**Subject:** MHI's Response to US-APWR DCD RAI No. 426-3167 REVISION 1

Response to Request for Additional Information  
No. 426-3167 Revision 1

**RAI NO.:** NO. 426-3167 REVISION 1  
**SRP SECTION:** 09.03.03—Equipment and Floor Drainage System  
**APPLICATION SECTION:** 9.3.3  
**DATE OF RAI ISSUE:** 7/30/2009

Figure 9.3.3-1 Equipment and Floor Drain System Flow Schematic Radiological Controlled Area (Sheet 1 of 2)

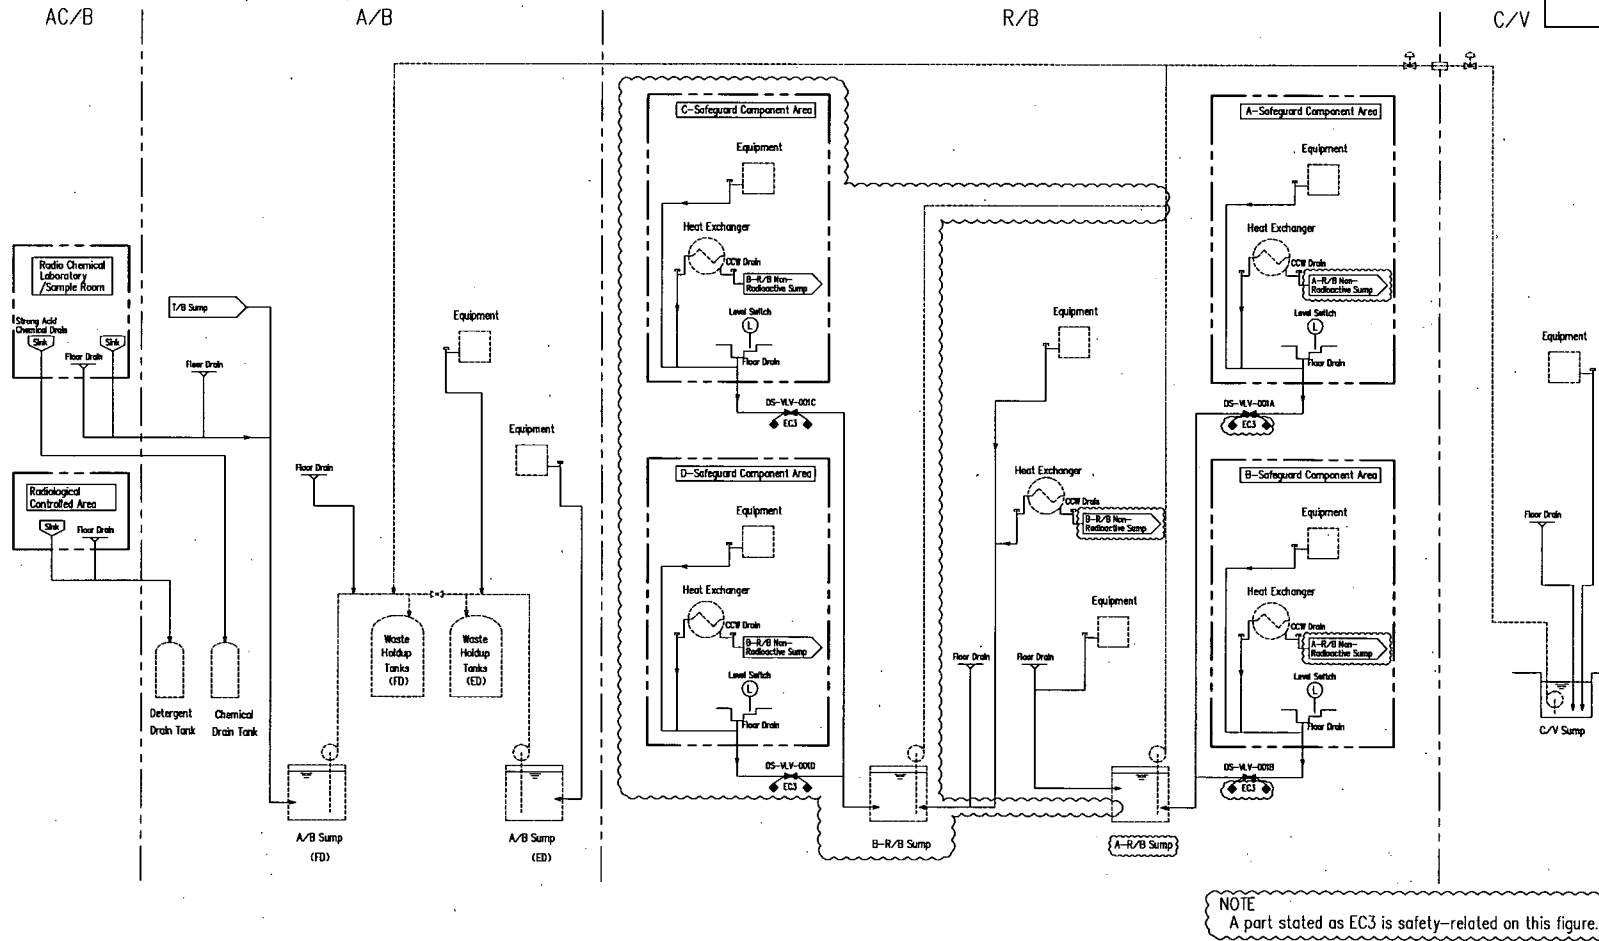
Upon further review of DCD Section 9.3.3, the staff found that the safety-related ESF equipment room isolation valves do not have any distinctive representation of being safety-related components and are only referred to as "isolation valves" (Section 9.3.3.1.1). In Section 9.3.3.2.2, the component description of the manually-operated valve also did not designate it as a safety-related isolation valve.

GDC 2 is applicable to all safety-related portions being capable of withstanding the effects of natural phenomena. The staff followed SRP 9.3.3, Section III to review the applicant's revision 2 to Figure 9.3.3-1 (submitted on May 14, 2009, in response to Request for Additional Information 299-2036) and notes that the safety-related valves and portions (for example: piping, isolation valves) are not explicitly labeled. Therefore, the staff is unable to determine compliance with GDC 2. Furthermore, the staff requests clarification on the safety designation of the valve on the transfer line between the C/V and R/B.

The staff requests that all references to safety-related isolation valves and piping should be clearly distinguished from non-safety related valves in the DCD Section 9.3.3 and Figure 9.3.3-1. Revise Figure 9.3.3-1 to clearly define component classification and quality class to distinguish between safety and non-safety portions of the EFDS.

In order to demonstrate compliance with GDC 60, the applicant must show suitable control to avoid inadvertent transfer or [of] radioactive waste to non-radioactive waste portions of the system. Upon staff review of Figure 9.3.3-1, revision 2, it appears that liquid effluent has a route for draining into either radioactive or non-radioactive sump in the same area of the A/B and R/B.

- Figure 9.3.3-1 (Sheet 1 of 2) shows an equipment and floor drain located in the R/B that drains directly into "R/B Sump" (radioactive). However, Figure 9.3.3-1 (sheet 2 of 2) also shows an equipment and floor drain located in the R/B that drains directly into the "R/B Non-Radioactive Sump" (non-radioactive).
- Figure 9.3.3-1 (Sheet 1 of 2) shows an equipment and floor drain located in the A/B that drains directly into "A/B Sump" (radioactive). However, Figure 9.3.3-1 (sheet 2 of 2) also shows an equipment and floor drain located in the A/B that drains directly into the "R/B Non-Radioactive Sump" (non-radioactive).

The applicant is requested to provide justification for providing floor drains discharging into both radioactive and non-radioactive sumps in the same building and how radioactive waste is precluded from draining into non-radioactive sump.

DCD Subsection 9.3.3.1.1 states that "The equipment and floor drainage systems are not safety-related and serve no safety-related function except the isolation valves installed in the drainage piping from engineered safety feature (ESF) equipment rooms." Accordingly, the valves DS-VLV-001A/B/C/D are safety classification. Figure 9.3.3-1 will be revised to define component classification and quality class to distinguish between safety and non-safety portions of the EFDS. In addition, Figure 9.3.3-1 will incorporate the following changes:

- Add another R/B sump and delete the valve numbered DS-VLV-002 with forming the basemat of R/B rectangularly.
- Add another R/B non-radioactive sump and delete the valves numbered DS-VLV-100 through 102 in the same manner as above.

- Figure 9.3.3-1 will be replaced with the attachment 1.
- The proposed change on the statement in Item 25 of Table 3.2-2 per the response to RAI 299-2036 Question 09.03.03-2 will be revised to read:

"Drain piping valves related to ESF rooms drain isolation ~~DS-VLV-001A through DS-VLV-002,~~ and ~~DS-VLV-100 through 102~~ DS-VLV-001A through DS-LVL-001D"

Figure 9.3.3-1 (Sheet 1 of 2) shows the equipment and floor drains located in the radiological controlled area (RCA), and Figure 9.3.3-1 (Sheet 2 of 2) shows the equipment and floor drains located in the non-radiological controlled area (NRCA). The radiological and non-radiological sumps are physically separated by floors and walls, and are located in different areas within the R/B. The R/B sumps in the RCA are located in the plant north, and the R/B sumps in the NRCA are located in the plant south side of the reactor building.

Figure 9.3.3-1 (Sheet 1 of 2) and (Sheet 2 of 2) titles will be revised to differential between the radioactive and non-radioactive sumps. Refer to Attachment 1 for the title revision.

Figure 9.3.3-1 Equipment and Floor Drain System Flow Schematic Non-radiological Controlled Area (Sheet 2 of 2)

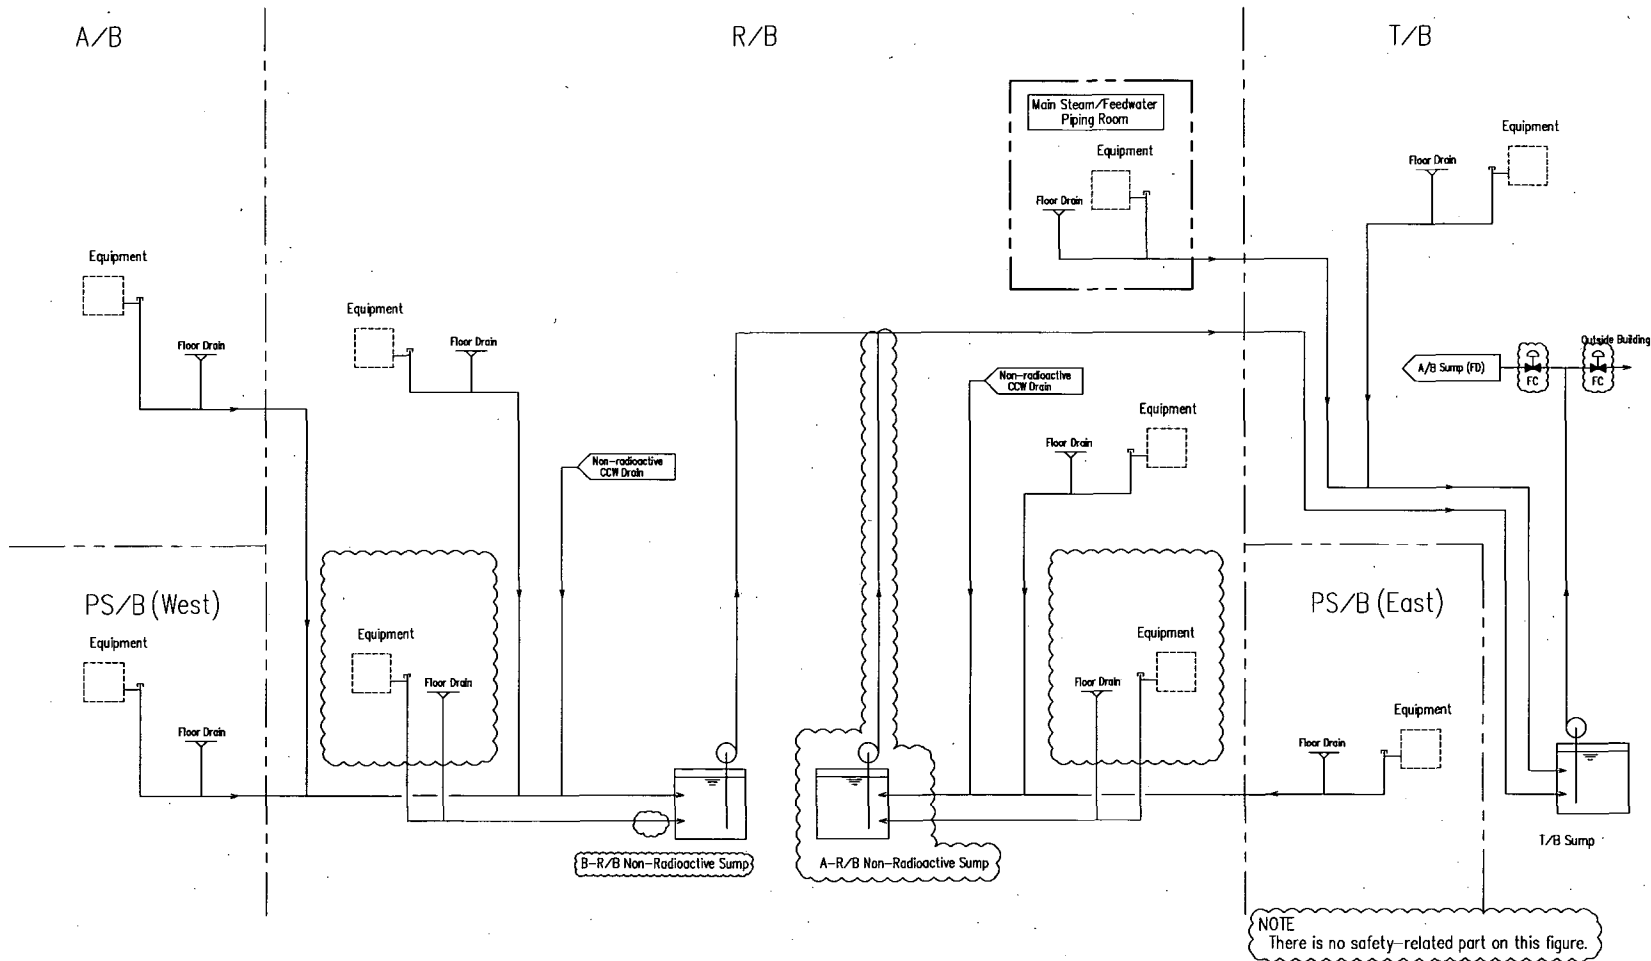
In order to demonstrate compliance with GDC 60, the applicant must show suitable control to avoid inadvertent transfer of radioactive waste to non-radioactive waste portions of the system. Review of Figure 9.3.3-1, revision 2, indicated that applicant has added two normally-closed valves to the T/B sump discharge. With the figure depicting flow through both non-radioactive and radioactive discharge paths closed off, it is not clear which valve configuration is appropriate for normal operation.

Provide an explanation of the two normally closed valves added to the T/B sump discharge. It is not clear from the schematic whether normal operation will discharge to the A/B sump (FD) or outside the building. The staff requests further clarification on the method used to open the valves for proper configuration in order to avoid cross-contamination.

The applicant is also to discuss whether the connection is inconsistent with the Tier 1 Section 2.7.6.8.1 statement, "The drain systems are designed with no cross-connection between the radioactive and non-radioactive drainage system to prevent contamination due to possible backflow."

As stated in DCD, Subsection 9.3.3.2.3, the Turbine Building (T/B) sump collects drains from equipment and floor drainage in the T/B, and non-radioactive sumps in the R/B and the main steam/feed water piping room. During normal operation, these drains are non-radioactive and are sent to outside building waste water treatment system for processing. The T/B sump pump is equipped with a level switch, which automatically starts or stops the pump at preset levels. The switch also opens the discharge valve to the outside building. When a pre-determined contamination level is reached, the radiation monitor initiates a signal to automatically shut off the valve to the outside building, opens the discharge valve to automatically divert the flow to the LWMS via the A/B floor drain sump, and alarms in the MCR. Both valves are designed to be failed close.

The current design is not inconsistent with the Tier 1 statement as the T/B sump (at reference elevation 3' 7") is above the A/B sump (at reference elevation -26' 4"), thus prevents backflow of the radioactive liquid to the non-radioactive drainage system.

- Attachment 1 shows the mark-up of the Figure 9.3.3-1 to add automatic valve operators as indicated in DCD Section 9.3.3.2.3.
- DCD subsection 9.3.3.2.3.D on "Turbine building sump" will be revised as follows to reflect Figure 9.3.3-1 (sheet 2 of 2) information.

"The T/B drain sump collects drain from all equipment and floor drainage in the T/B and non-radioactive drain sump. This sump normally discharges to the WWS for treatment. However, if it should become contaminated, the discharge is automatically diverted to LWMS via the A/B Sump. Radiation monitor located in the Turbine building sump, which alarms in the MCR when a pre-determined contamination level is reached. Upon receipt of a radiation signal the discharge valve is automatically shutoff and the waste water of the sump is pumped to the LWMS via the A/B Sump for treatment, as described described in Chapter 11 Section 11.2."
